1966 - 1967 Corvette: Service Bulletin: Crankshaft to Water Pump Drive Belt Failure

Subject: Crankshaft to Water Pump Drive Belt Failure
Model and Year: 1966 - 1967 Corvettes with 427 CU. IN. Engine and Air Conditioning
Source: Chevrolet Service Technical Bulletin
Bulletin No: 67-T-26
Section: VI
Date: Sept. 26, 1967

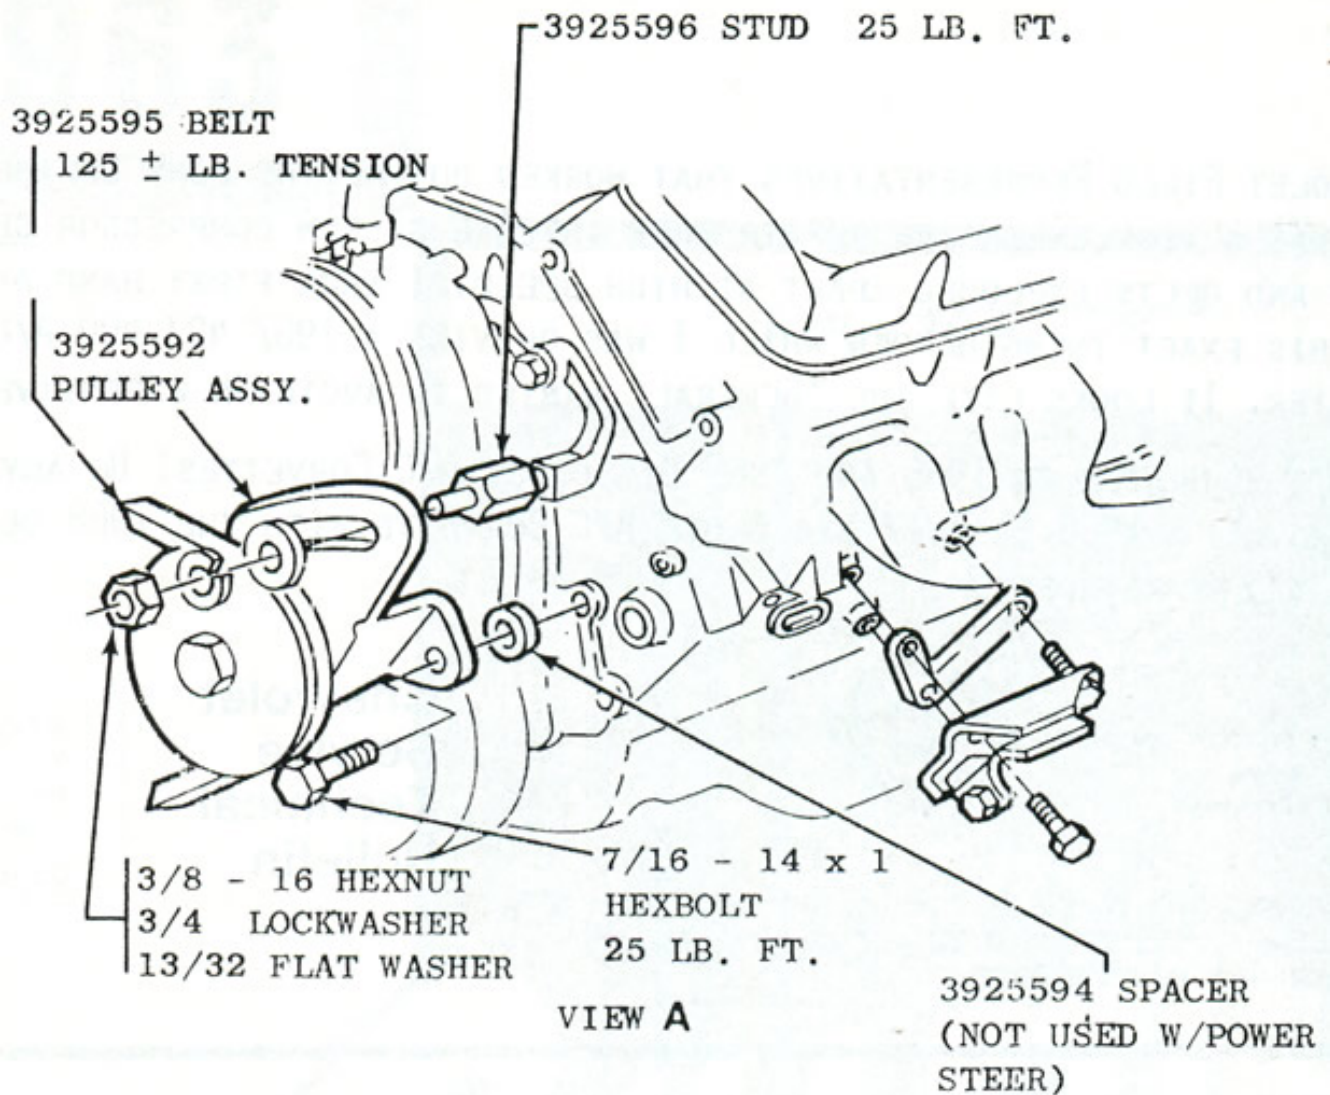
Reports have been received of crankshaft to water pump drive belt failures on 1966 and 1967 Corvettes equipped with 427 cubic inch engine and air conditioning. The belt failure occurs when the air conditioning compressor stalls under high head pressure after extreme hot soak conditions. With the compressor stalled, the water pump and the drive belt between the crankshaft and water pump also stall. As the crankshaft pulley continues to rotate, the crankshaft to water pump drive belt fails due to overheating and wear.

To permit belt tension adjustment between the crankshaft and water pump, 1968 Corvettes equipped with 427 cubic inch engine and air conditioning will incorporate an idler pulley shown in Figure 1.

In service, a similar idler pulley and longer drive belt can be installed to permit belt tension adjustment and correct the condition of belt slippage and wear. Parts information and installation instructions are illustrated in Figure 1
